**RE: Meridian Service Metropolitan District  
Water Treatment Plant Expansion  
Site Development Plan – Letter of Intent**

Add PCD File #  
PPR-22-012

Figure 1. Existing and Proposed Parcels Exhibit

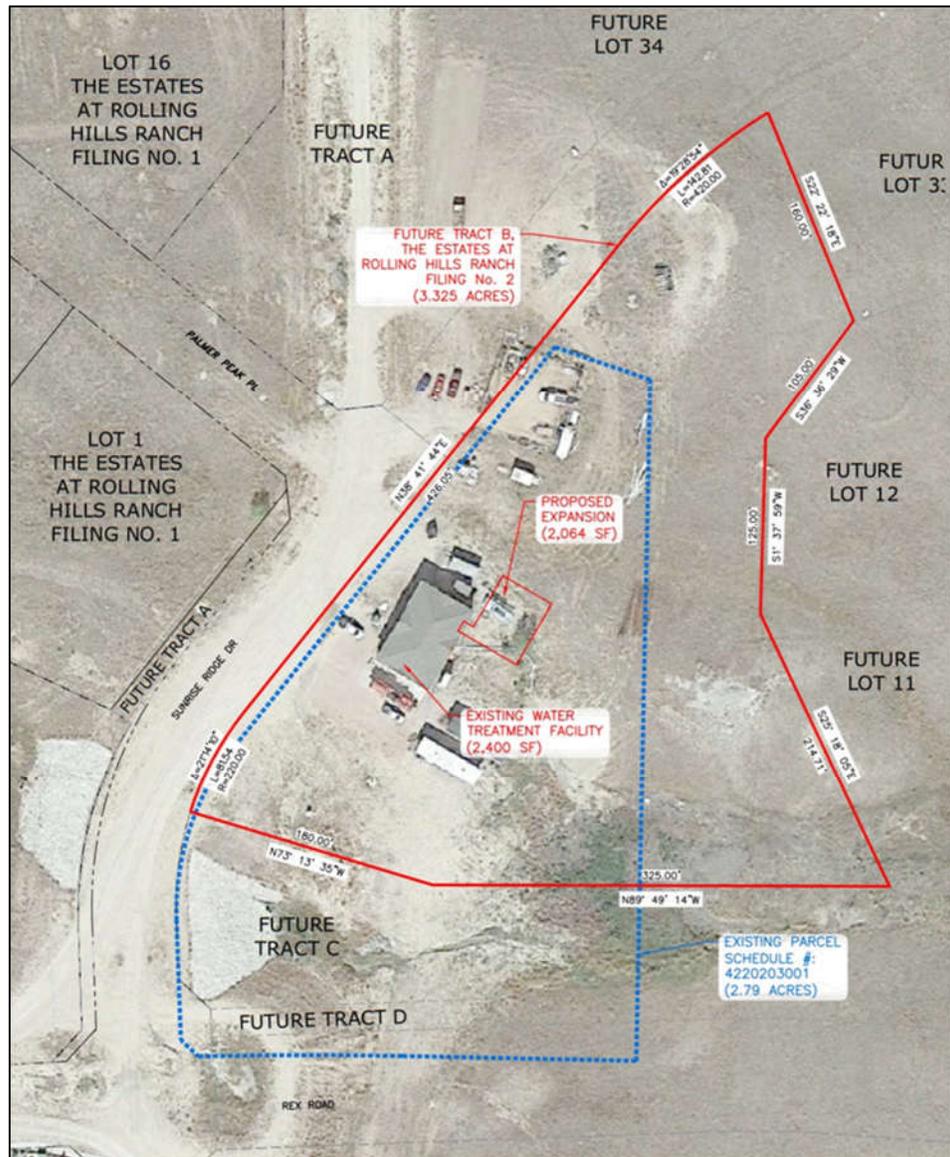
Please provide details on the original site plan for the existing building.
